Enquiry No. 1126.  
 also No. 770 (app'd 27.6.05)  
 No. 761 Ships.

Section showing Proposed Amended Arrangement of Shell Plating.

Messrs. Armstrong Whitworth & Co. Ltd.  
Amended Arrangement of Shell Plating.  
No. 761 Ship.  
4 to 770

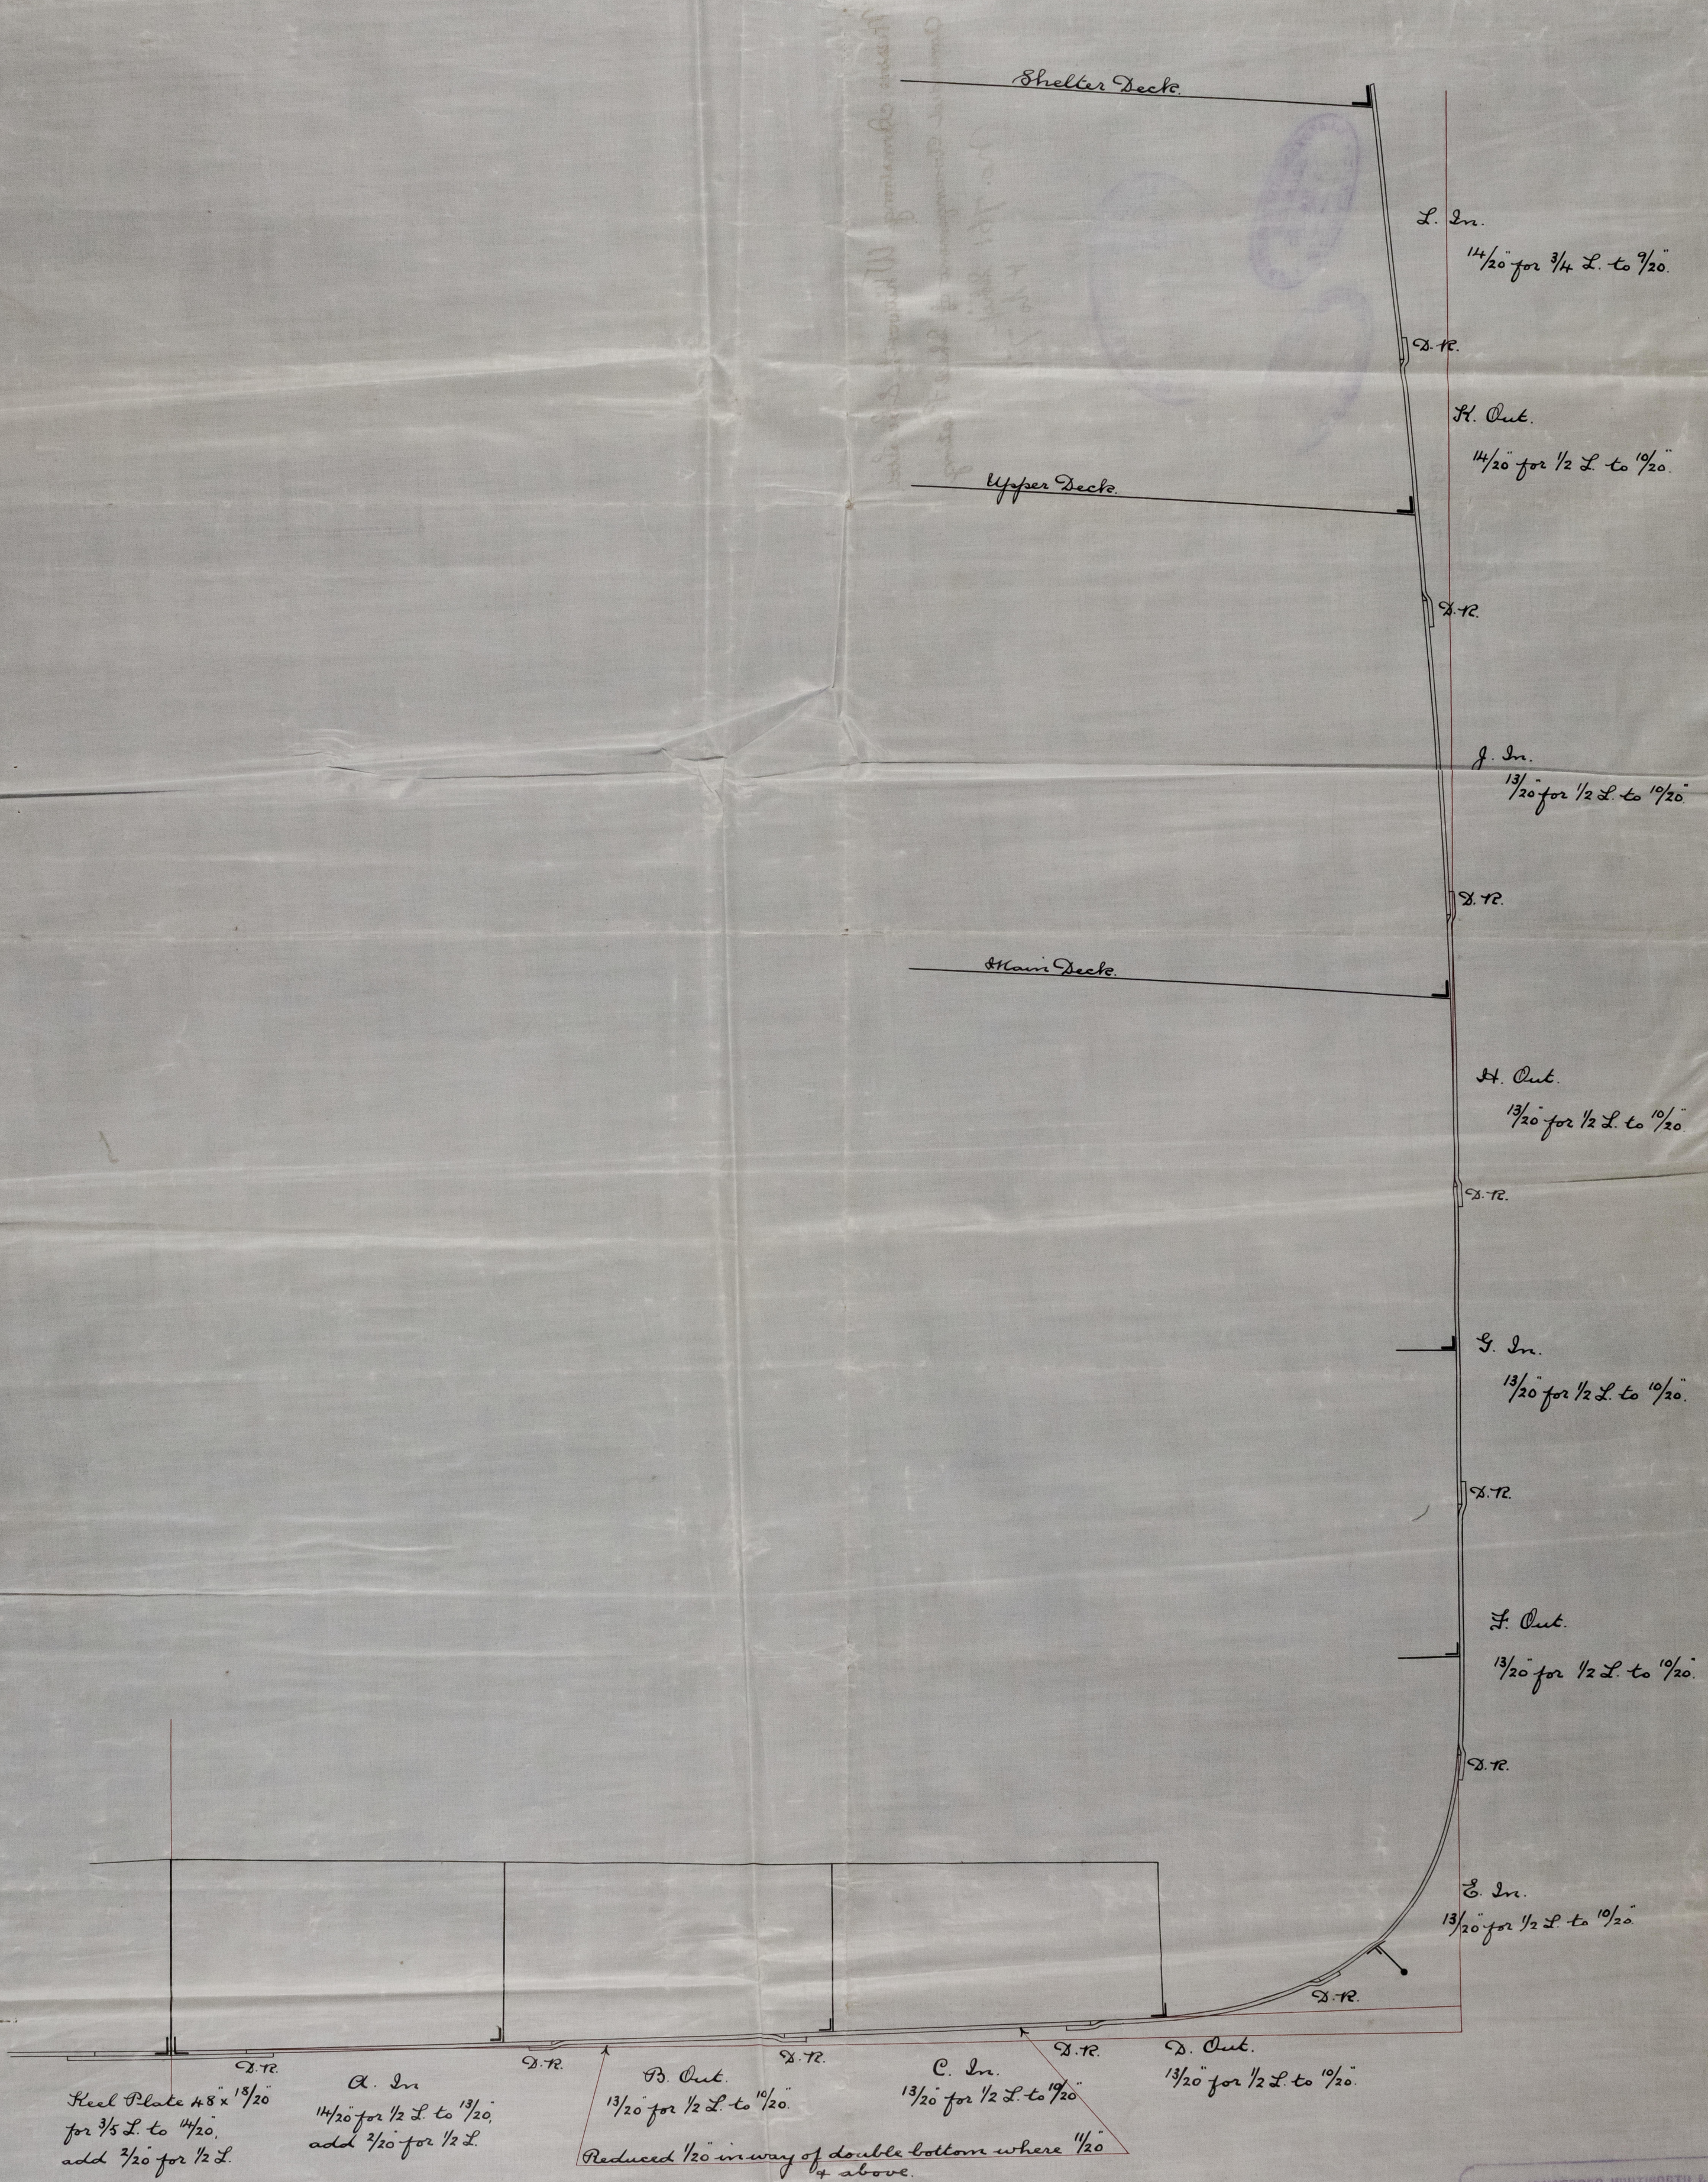
B. & C. Strakes midship thickness to be maintained  
 fwd. to collision bulkhead.
